UNITED STATES NUCLEAR REGULATORY COMMISSIONDOCKET NO. 50-498 OLHOUSTON LIGHTING AND POWER COMPANY(SOUTH TEXAS PROJECT, UNIT 1)ISSUANCE OF DIRECTOR'S DECISION UNDER 10 CFR 2.206 (DD-88-3)

NRC Safety Significance Assessment Team Report on allegations related to the South Texas Project, Units 1 and 2

Docket Nos. 50-498 and 50-499

Houston Lighting and Power Company

Figure 5.5-1 Weldments Showing Typical Bead Characteristics of E7018 and E6011 Weld Rods

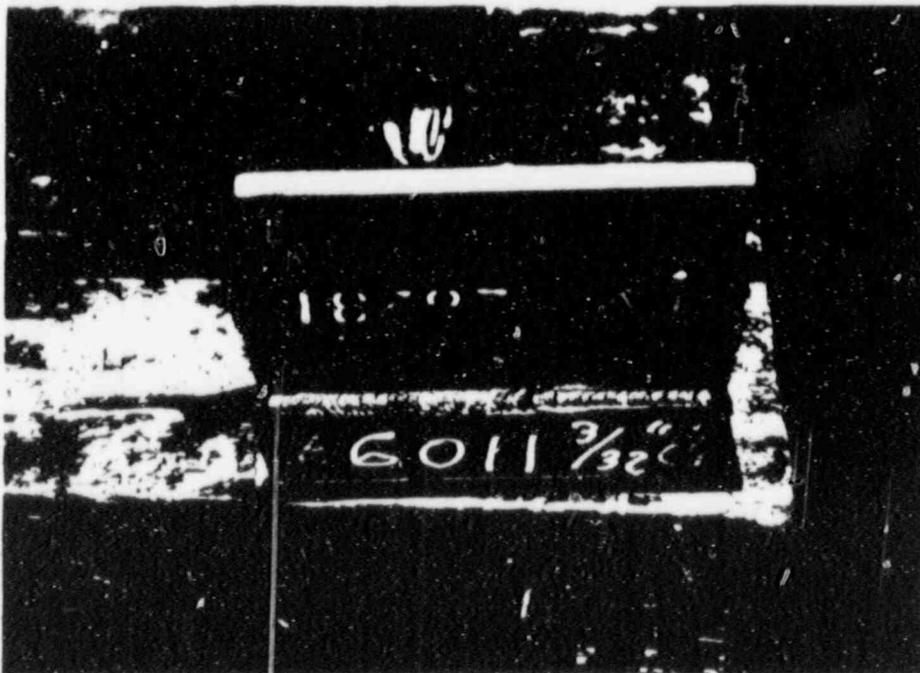
In an effort to determine whether the E7018 electrodes in the unacceptable lot had been used in place of E6010 or E6011 electrodes for HVAC welding, the SSAT requested Ebasco to prepare weldments of the same material used in the HVAC system with two different type electrodes, E6011 and E7018. This was done to ascertain the typical bead characteristics of each electrode to aid in the HVAC weld inspections. The welds made with the E7018 electrode show a smoother surface profile than welds made with the E6011 rod (see Figure 5.5-1(a) and (b)).

The SSAT conducted an extensive visual inspection of numerous welds on ducts and supports in the HVAC system in the MEAB, RCB, DGB, FHB, and the space above the control room. Although most of the welds had been painted, thereby making it difficult to fully interpret each of the weldment characteristics, the visual inspections performed on the welds were sufficient to allow the SSAT to determine whether the welds were of good quality and appeared to meet design specifications and AWS Code requirements. In addition, 14 HVAC system support construction packages were reviewed by the SSAT for dates of final signoff and completeness and compared to the filler material issue record (FMIR) dates. Also, the SSAT reviewed the certifications of the welders who performed the welds on these supports. The SSAT determined that the documents were in order, the correct welding electrodes were issued, and the welders were qualified to weld to both applicable welding procedures, WP-167 and WP-5. The SSAT also determined that these weldments had been inspected and accepted by the QC organization.

Figure 5.6-3 Flexible Conduit Installation Reviewed by SAFETEM-Dispositioned Use As Is

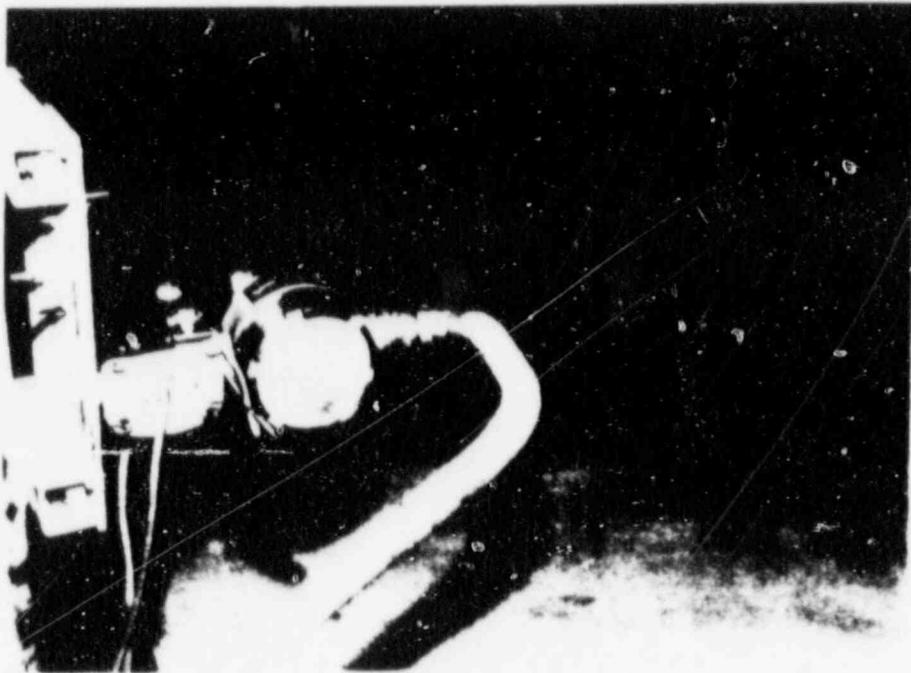
It is alleged that flexible metallic conduit was bent to form a radius that was below the minimum bend radius (MBR) permitted in seven instances. The SSAT interviewed the alleged who indicated that the seven concerns had been brought to the attention of HL&P's SAFETEAM.

- (3) At elevation 31 feet in the Unit 1 mechanical and electrical auxiliary building (MEAB), room 106A, the conduit leading to a limitorque-type motor-operated valve was in a passageway and could be potentially damaged. This installation had been inspected and NCR CE05256, dated December 12, 1986, identified that the permanent identification tag was damaged and the flexible hose was broken. The tag was replaced and was verified to be acceptable on April 21, 1987. Design change notices (DCNs) 4 and 5 were initiated to rotate the valve actuator by 180° to remove it from the passageway. The valve is scheduled to be rotated during the first refueling outage.

- (4) At elevation 10 feet in room 035 in the MEAB, Unit 1, the bend radius for an FMC on instrument DICB-TSH-00240 was found to be 4 inches. This condition was dispositioned and found acceptable, since the MBR of the cable within the conduit was 1.8 inch.

Figure 5.6-4 Flexible Conduit Installations With Apparent Bend Radius Violations

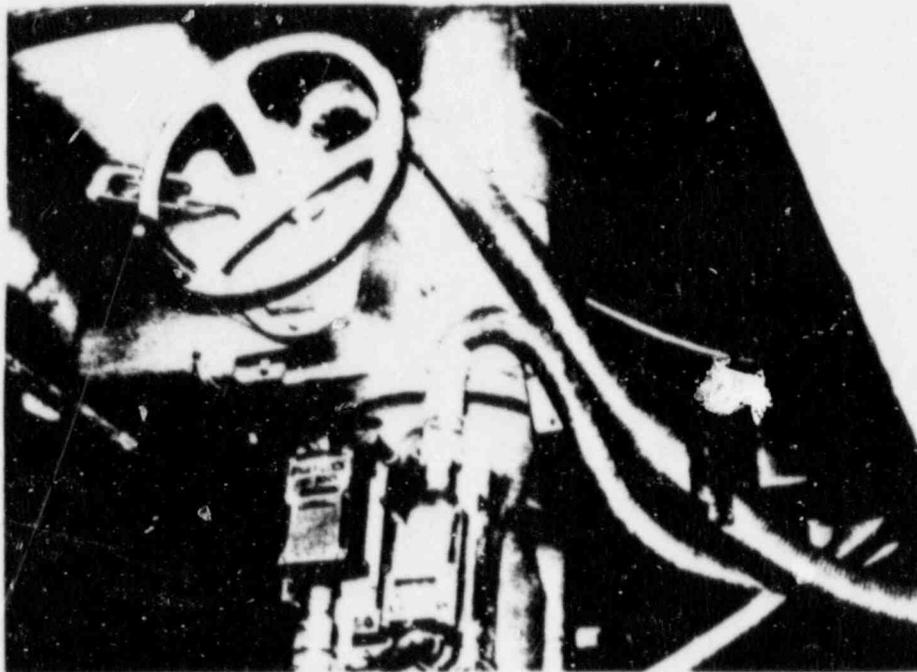
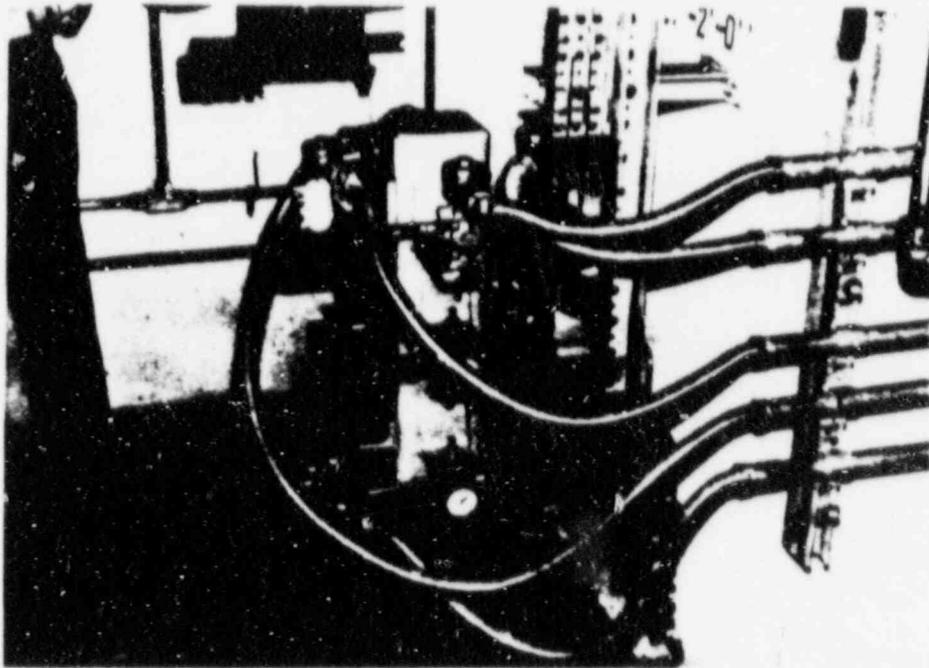
(a) Installation on Solenoid Valve - Cable Bend Radius Not Violated

(b) Installation to Limit Switch - Cable Bend Radius Not Violated
